**Town of Carmel
60 McAlpin Avenue
Mahopac, NY 10541
RE: Clapboard Ridge; Mahopac, NY
500,000 Gallon GST
March 25, 2019
Mr. Rich Franzetti
Engineer
(845) 628-1500 x181
Job No. 319099-I**

GROUND STORAGE INSPECTION REPORT

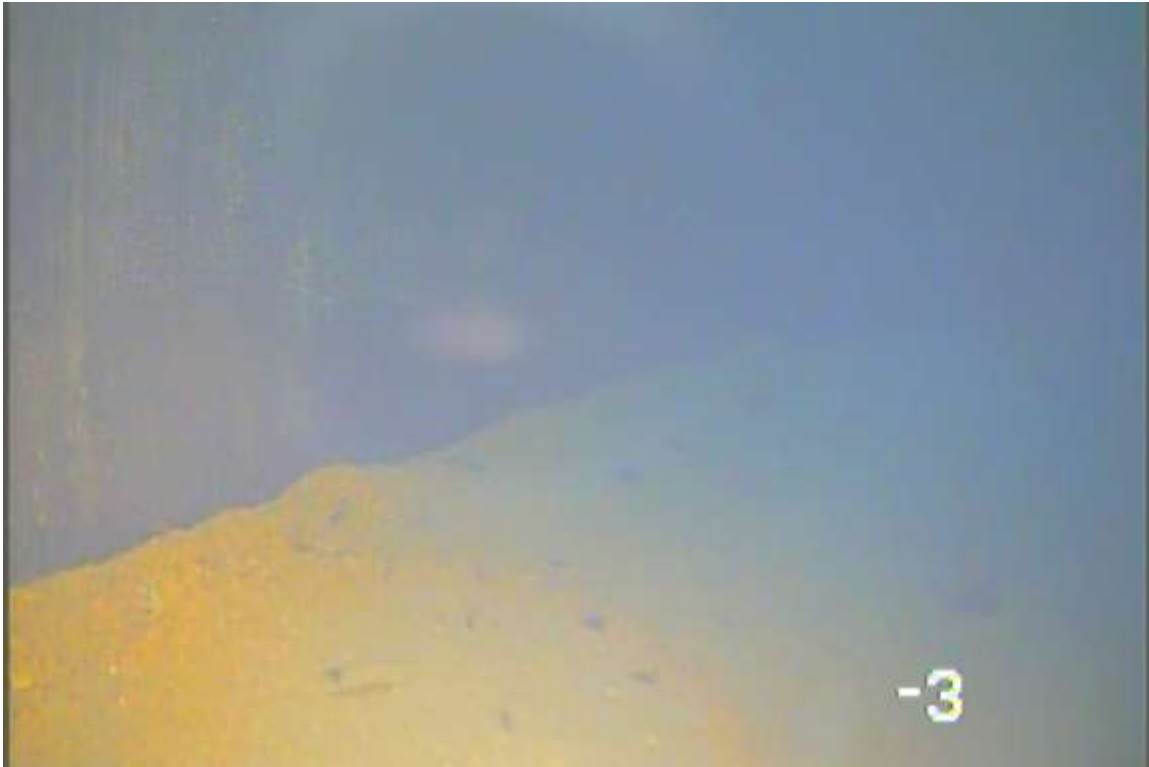
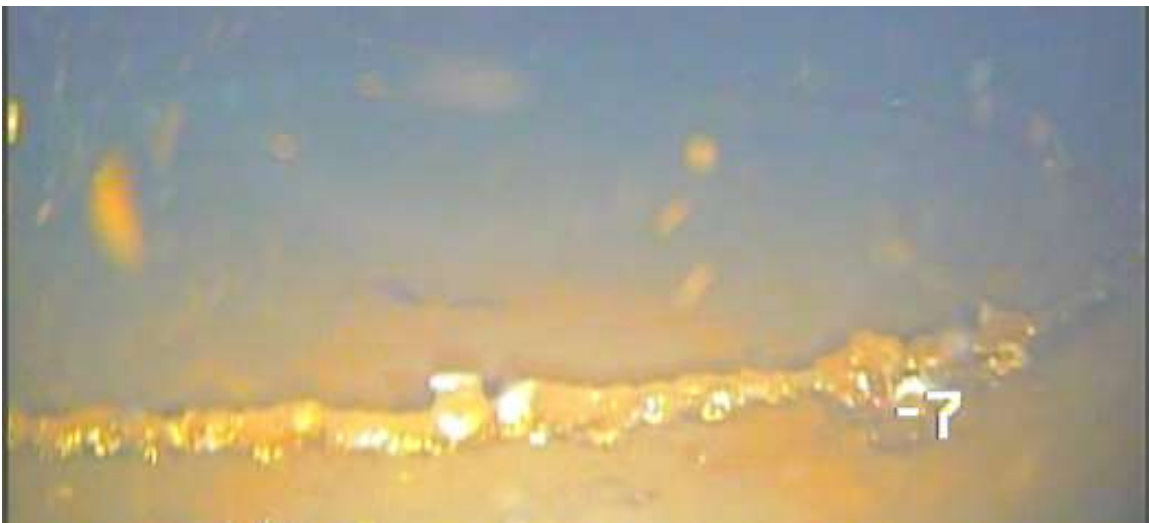
Top photo shows the interior roof lap seams, which appear to be in good condition.

Bottom photo shows the interior roof-to-rim angle connection, which appears to be in good condition.
